## **Annexure 4:**

Responses to s92 requests prepared by GHD in respect of surface and groundwater matters

**Response to Section 92 request for further information – Macraes Phase IV**

GHD provides this letter in response to Otago Regional Council’s request for further information letter under Section 92(1) of the Resource Management Act for consent application number RM.24.184.

Figure 1. Hydraulic Conductivity testing – GPUG Area (from WSP, 2023)

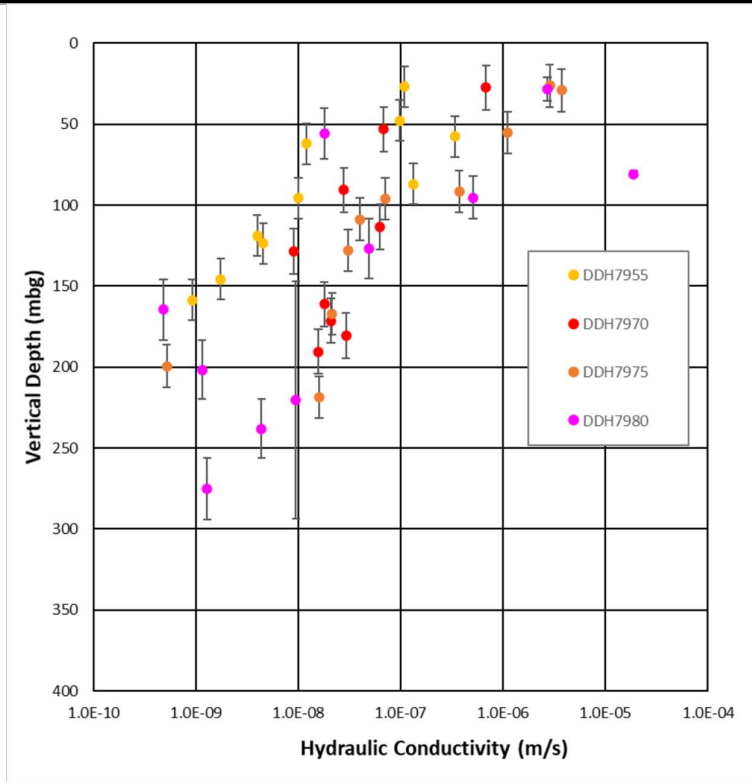
4.4	<p><b>Steady state calibration from the groundwater models results in lower conductivity layers (Table 4.1) than expected based on the hydraulic testing summary. Please discuss the calibration achieved when using the test results as per Table 3.1 and the justification for the variation.</b></p>
	<p>None of the historical or recent models use the exact same hydraulic conductivity values presented in Table 3.1. The GHD 2024 model generally used lower hydraulic conductivity values compared to those listed in Table 3.2 from CD Smith although there is an overlap in values for the moderately and slightly weathered material in model layers 1 and 2. Previous work undertaken by Kingett Mitchell and Golder Associates reported in Appendix B of the GHD Report "Macraes Phase IV. Stage 3 - Surface and Groundwater Assessment. 26 March 2024" (Appendix 13 of the AEE) show hydraulically conductivity decreasing with depth as a result of decreased weathering. This has been confirmed by recent drilling (2022) undertaken in the GPUG area and reported by WSP (WSP, 2023. Golden Point Underground Mine (GPUG), GPUG Extension Hydrogeological Assessment. 26 April 2023). Figure 4 from this report is reproduced here (Figure 1) and shows the relationship between K and vertical depth in the GPUG area. The values used in the GHD model are consistent with, and within the ranges of values presented by other authors as shown in 'Appendix B- Table A-1 Summary of Hydrogeological properties applied in previous groundwater models' based on site testing results and model calibration. Values used in the modelling consider some reduction in hydraulic conductivity with depth. This is considered to fit better with the site conceptual model.</p>

CDM Smith (2016) undertook a review of the available hydrogeological data on site and an interpreted summary is presented in Table 3.1. Therefore Table 3.1 is a summary of test results undertaken over the years as detailed in Appendix B. The modelling undertaken by CDM Smith in 2016 undertook a simpler approach and used one value to represent the hydraulic conductivity of schist throughout the whole model i.e. their adopted  $k$  values do not differentiate between fresh and unweathered schist, even though these materials are expected to have some differences.

As discussed in the Appendix 11 of the AEE (GHD (2024a)), GHD also tested the approach undertaken by CDM Smith by lumping layers 2 – 8, rather than splitting them out to show a decreasing hydraulic conductivity with depth (although this was tested). The calibration of this second model was slightly better but overall, the results from both models were similar.

Figure A.3 Groundwater take consents (existing and proposed) and maximum plume extent in model layer 6 after 400 years. Plume extent from Macraes Phase IV, Stage 3 – Surface and Groundwater Assessment – site wide model

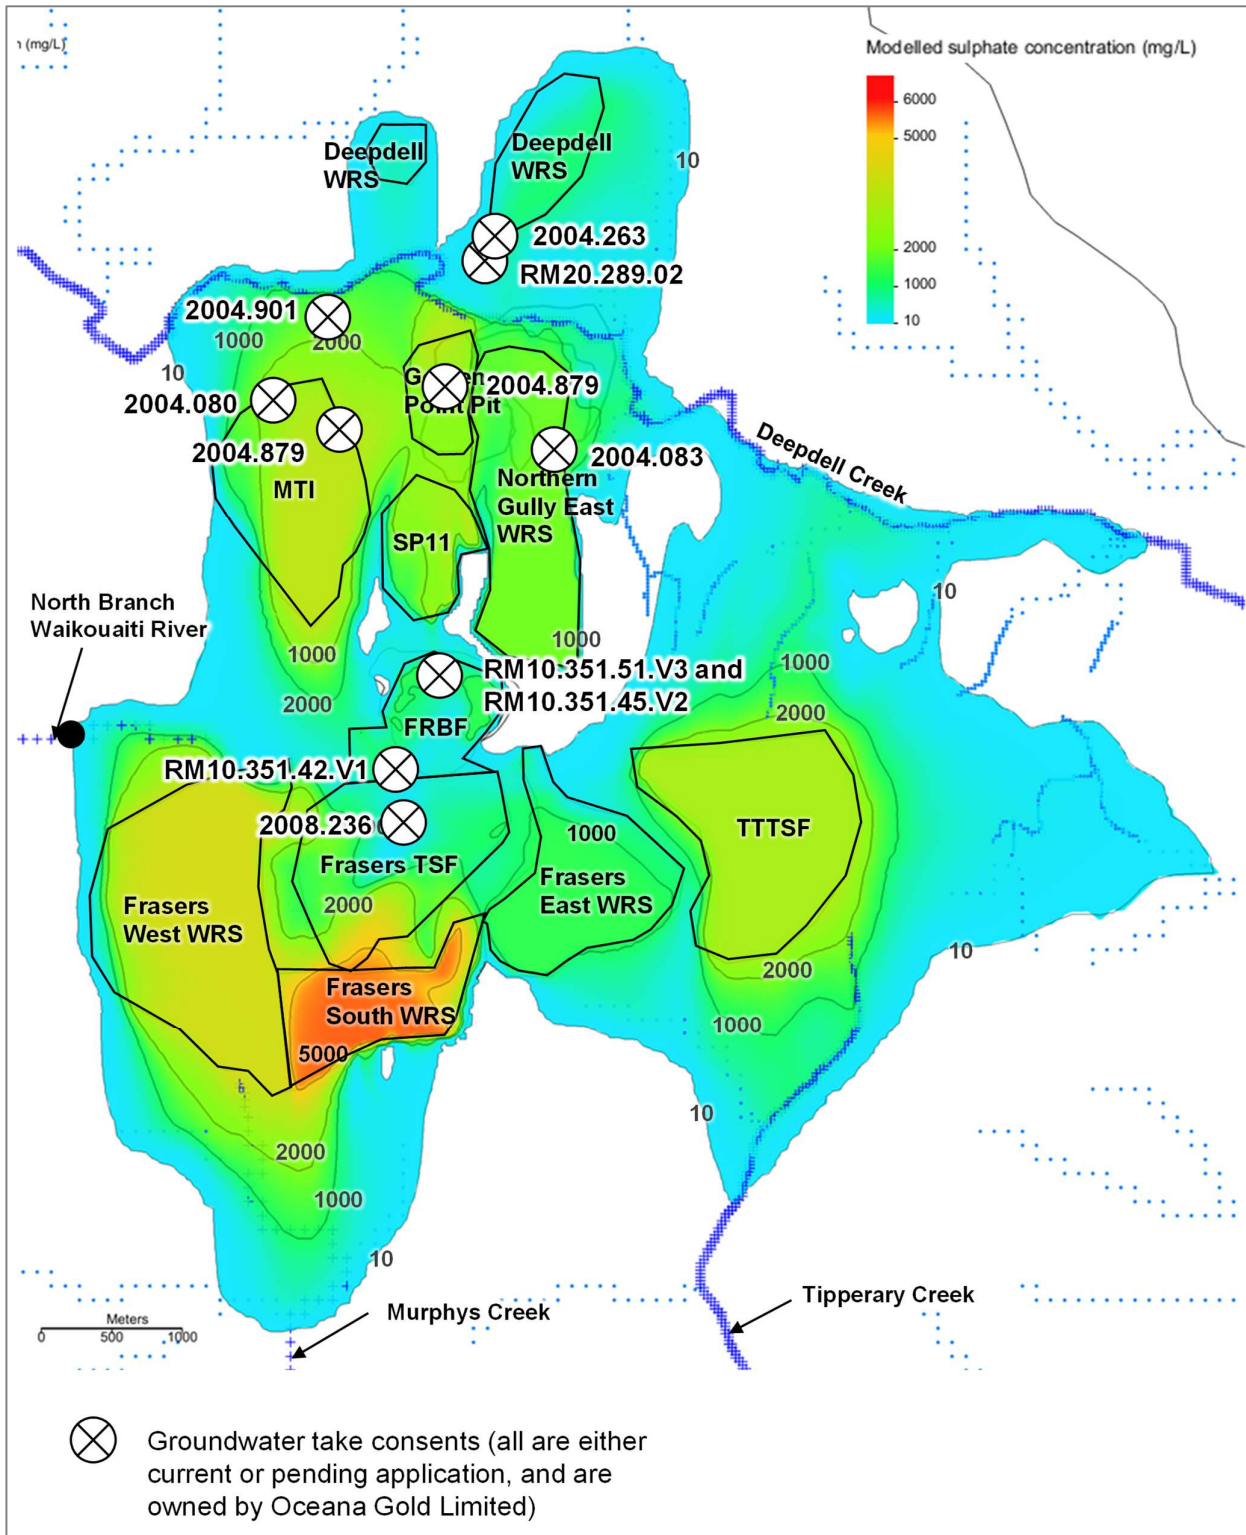
Item	Question / Response
1.15	<p><b>Based on the data in the GHD reports and any other relevant information, please provide an assessment of the adverse effects of the MP4 proposal upon groundwater quality, and the effects upon current and future users of groundwater. Only a surface water assessment is provided (Ryder) with the application. Groundwater is also a resource and effects on this resource should be considered directly, not just in terms of its function as a conduit for contaminants to migrate into surface water.</b></p>
	<p><i>The zone of influence (in terms of groundwater drawdown and groundwater contamination) is limited to areas within the mine footprint.</i></p> <p><i>Monitoring and modelling results (Section 4 – in GHD reports) indicate that groundwater drawdown (from current &amp; proposed mine activities) is shown to be limited to areas immediately adjacent the current pits and drawdown over a wider area (as a result of mining activities – current and/or proposed) is considered unlikely.</i></p> <p><i>The modelling shows groundwater contamination (represented by sulphate as a conservative indication of groundwater plume development due to its elevated nature – in the discharge, and low ability to attenuate within the groundwater system) is largely contained to areas immediately surrounding mine facilities and structures (i.e. waste rock stacks, tailings facilities and open pits). (Refer to Figures A3-A7 in Appendix A).</i></p> <p><i>Appendix A Figure A-1 shows the location of existing and proposed bores (data from ORC’s database) owned by Oceana Gold (blue) and not owned by Oceana Gold (red). It has been assumed that any bores located within the OGC land ownership and mining permit areas that are not named are owned by Oceana Gold. There is one bore located just within these areas (I42/00086) that has the name of a private landowner and two bores just outside the OGC ownership boundary which area also named as private owners (I42/00088 and I42/00092).</i></p> <p><i>Appendix A Figure A-2 shows the existing and proposed groundwater take consents. sourced from Otago Maps. Consented groundwater takes within the mining permit and OGC property areas are all owned by Oceana Gold. The nearest consent not owned by Oceana Gold is located 3 km east of the OGC ownership boundary.</i></p> <p><i>Appendix A Figure A-3 shows the consented groundwater takes overlain onto the site wide model plume extent. All consented takes occurring within the plume are owned by Oceana Gold.</i></p> <p><i>Appendix A Figure A-4 shows all existing and proposed bores with the 400-year plume extent in model layer six for the <b>site wide model</b>. The results show that no private neighbouring bores occur within the contaminant plume.</i></p>

Item	Question / Response
	<p>Appendix A Figure A-5 and Figure A-6 show the maximum plume extents after 400 years for the Coronation model. The results show that no private neighbouring bores occur within the contaminant plume.</p> <p>Appendix A Figure A-7 shows the maximum plume extent from Golden Bar after 400 years. There are no private bores located within the plume.</p> <p>Based on the estimated limited plume extent, the proposed activities are not expected to have an adverse effect upon current and/or future users of groundwater.</p>
